PW082812-27

RE: Request to waive requirement to install sidewalk per City Ordinance 12.08.060

RE: PHASE 2 OF ST. MARTINS VILLAGE

SIDEWALK VARIANCE REQUEST

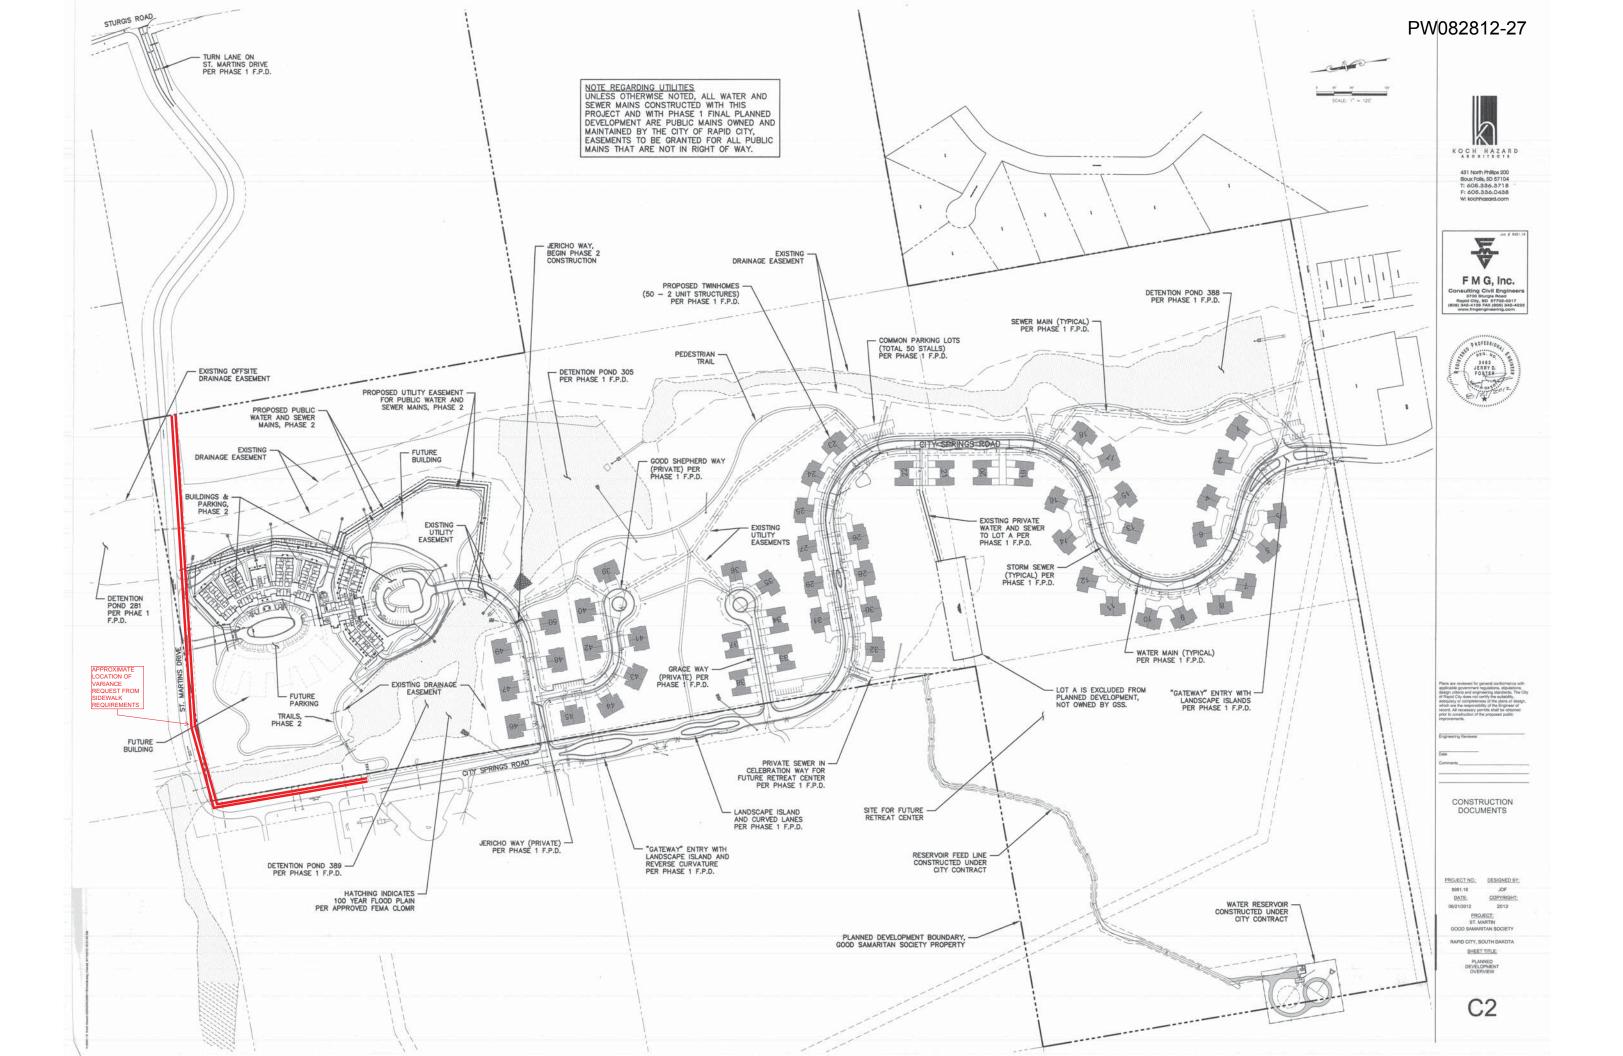
The project includes sidewalk along City Springs Road from the south end of the property to a point about 600' north of Jericho Way. It is requested that the sidewalk not be continued along City Springs Road beyond this point. The proposed end of the sidewalk as shown on the Engineering Drawings is at a point where the internal trail walkway enters the City Springs Road right of way.

Construction of a sidewalk along St. Martins Drive will be very difficult, if not impossible or cost prohibitive due to the presence of existing roadway drainage ditches, no curb and gutter, and very steep fill and cut slopes. The ditch slopes and cut/fill slopes essentially begin at the edge of the pavement and continue to and beyond the right of way lines.

A copy of the overall Civil Engineering Layout Sheet is attached showing the extent of the sidewalks and trails proposed with this project.

Staff Recommendation: Staff recommends the request to waive the requirement to install sidewalk be approved with the stipulation of recording a Waiver of Right to Protest (WORP).
